Service Information Letter

AD32-SIL-001

TITLE:	Altitude Alerter Function Removal
DOCUMENT NUMBER:	AD32-SIL-001
EQUIPMENT:	AD32 RVSM Air Data Display
© Copyright by THOMMEN AIRCRAFT EQUIPMENT AG, CH-4132 Muttenz, Switzerland

Figure 1 - Before Internal Altitude Alerter Function Removal

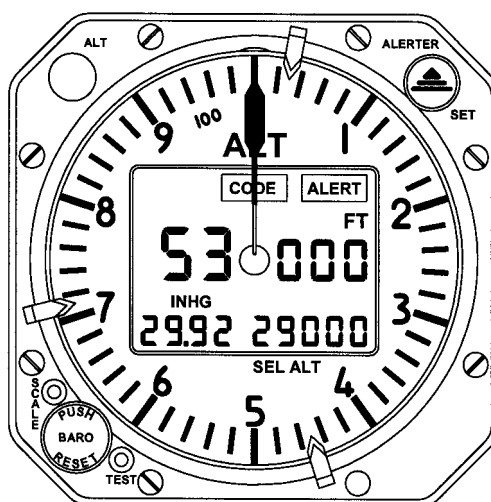
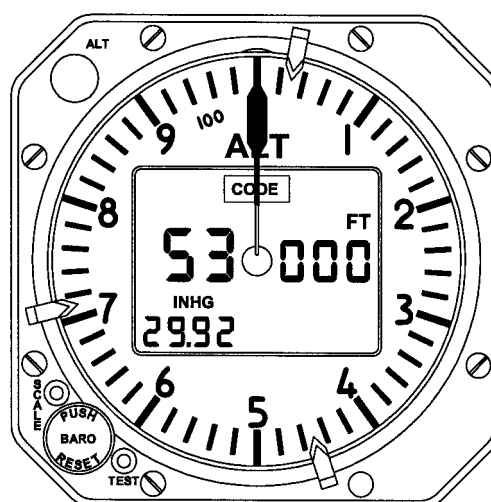
The altitude alerter knob will be completely removed and, as the removal of the knob will leave a hole in the bezel of the instrument, the bezel must be changed.

On the display, ALERT will be removed by software configuration and there will be a new dial without SEL ALT printed on it.

Figure 2 - After Internal Altitude Alerter Function Removal
